**STAFF REPORT
KETCHUM PLANNING AND ZONING COMMISSION
MEETING OF SEPTEMBER 27th, 2022**

PROJECT: Walnut & 4th Mixed-Use Building Design Review Amendment

FILE NUMBER: P20-046A

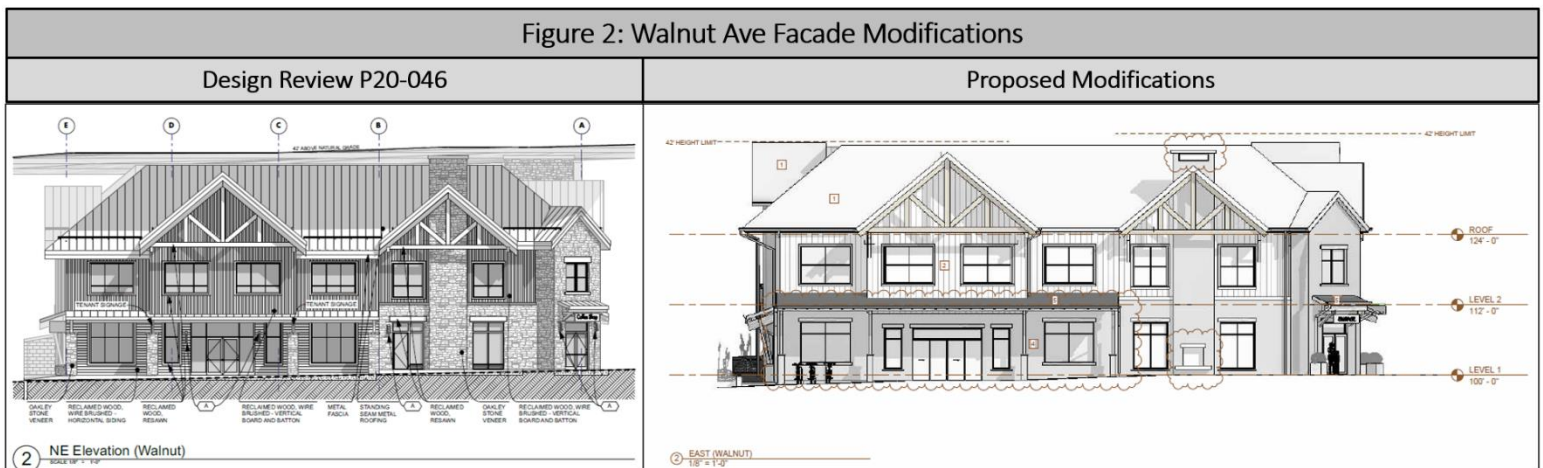
The applicant has replaced the wood siding proposed at the ground floor with stone veneer to comply with Fire Department standards requiring all exterior materials within 12 vertical inches of finished grade to be 1-hour rated, noncombustible material. The applicant has proposed enlarging the window above the building entrance at the 4th Street façade. The windows at the ground-level of the south elevation have been modified to a clerestory design. The applicant has modified the design of the guardrails at the upper-level balconies at the alley and interior side elevations. The original project plans approve with Design Review P20-046A proposed horizontal metal rails. The applicant has proposed modifying these guardrails to solid, stained wood panels to provide more privacy to the balconies.

The applicant has revised the proposed exterior lighting plan (See Figure 1). The project plans approved with Design Review P20-046 proposed 18 total wall sconces and 30 recessed can lights. Three different wall sconces were proposed with the original project plans approved with Design Review P20-046. The applicant has proposed 1 new exterior wall sconce to replace the 3 wall sconces that were approved with Design Review P20-046 and reduced the total number of wall sconces to 6 total fixtures.

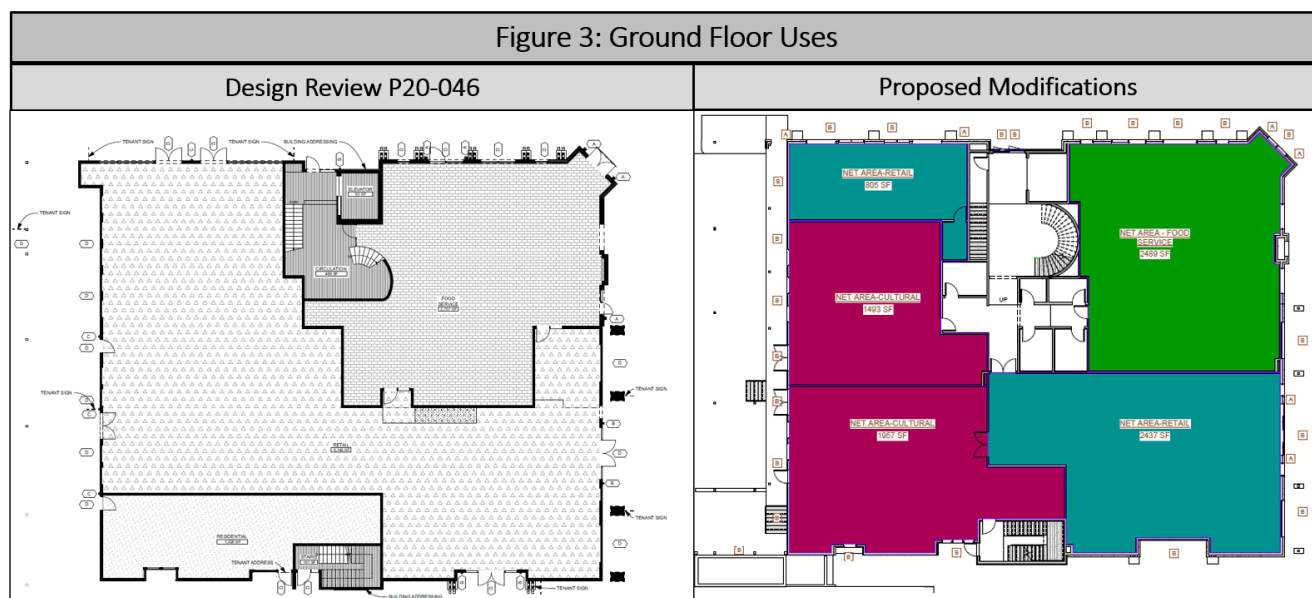
The applicant has proposed to modify the mixture of commercial uses on the ground level (See Figure 3). The original project plans approved by the Commission with Design Review Permit P20-046 included a market-rate residential unit at the back of the building along the alley on the ground floor. Residential units on the ground level with street frontage are prohibited in the CC-1 Zone. This residence was permitted on the ground level as the unit did not have any street frontage along Walnut Avenue or 4th Street. This market-rate residential unit has been removed from the ground floor. The total retail area on the ground level has been reduced by 2,854 square feet. The food service area at the street corner has been reduced by 268 square feet. The removal of the market-rate residential unit and the reduction in total retail and food service areas will accommodate a new 3,252-square-foot area for the Community Library Regional History Museum located on the ground level. The museum is qualified as a cultural facility use. Ketchum Municipal Code §17.08.020 defines cultural facility as an institution or use of land for the display, preservation, or exhibition of art, scientific, cultural, or historical materials, including, but not limited to, museums, libraries, or art galleries. Cultural facilities are a permitted use in the CC-1 Zone pursuant to Ketchum Municipal Code §17.12.020. While the total retail and food service areas have been reduced, these uses are proposed to remain at the street frontages along 4th Street and Walnut Avenue.
